## Airworthiness Directive

**AD No.:** 2018-0043

A380 aeroplanes

## ATA 71 – Power Plant – Rear Engine Mount Assembly – Inspection

Figure 1 – Rear engine mount beam

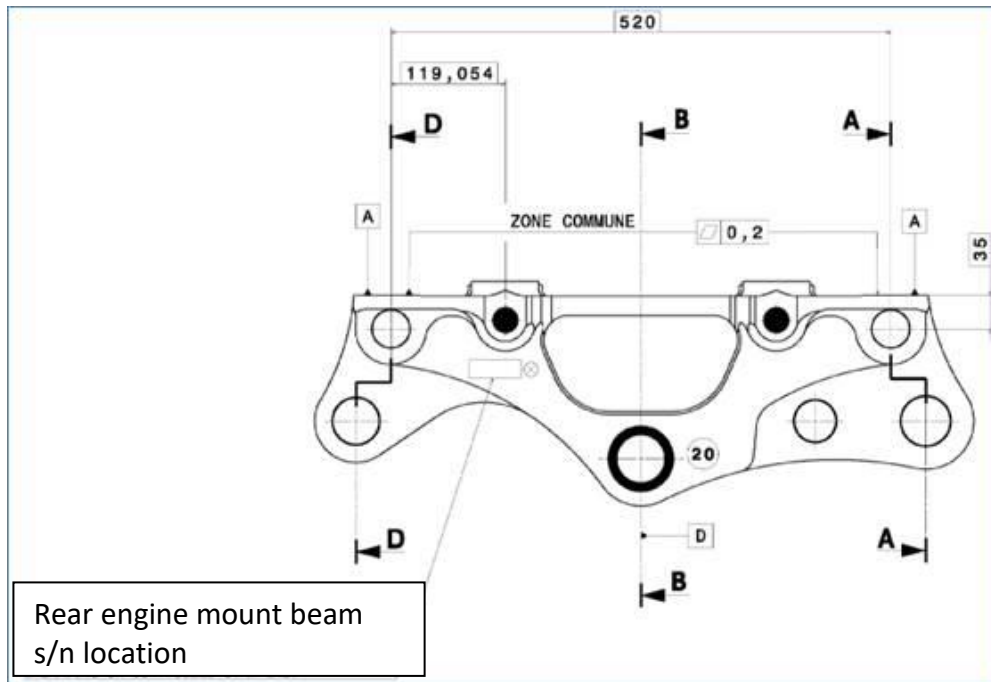
**Affected part:** Rear engine mount beams, Part Number (P/N) L7121076120000, except those with a serial number (s/n) as listed in Appendix 1 of this AD. For the location of the s/n of the beam, see Figure 1 of Appendix 2 of this AD.

Note 2: The s/n of the beam (in some cases with a prefix added by Airbus) is provided on the main body (back face) of the part, as shown in Figure 1 above.

Figure 2 – Rear engine mount assembly

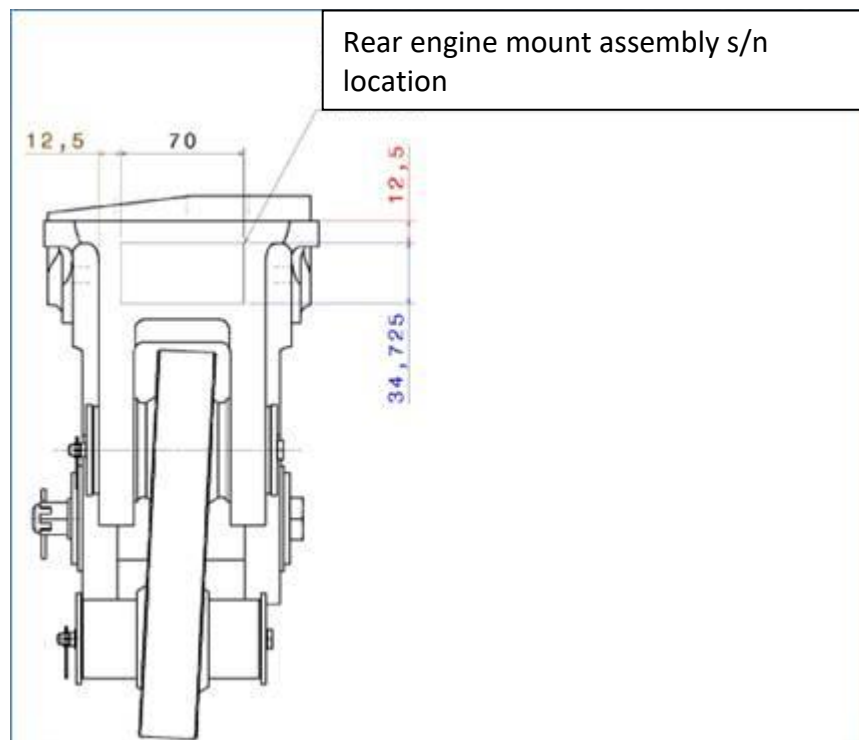
**Affected assembly:** Rear engine mount assemblies, P/N L7121016002000, P/N L7121016200000, and P/N L7121016500000 (where the number of zeros at the end of the P/N can vary), having an affected part installed, except those assemblies with a s/n as listed in Appendix 1 of this AD. For the location of the s/n of the assembly, see Figure 2 of Appendix 2 of this AD.

Note 3: The s/n of the rear engine mount assembly is provided on the left side of the part, as shown in Figure 2 above.
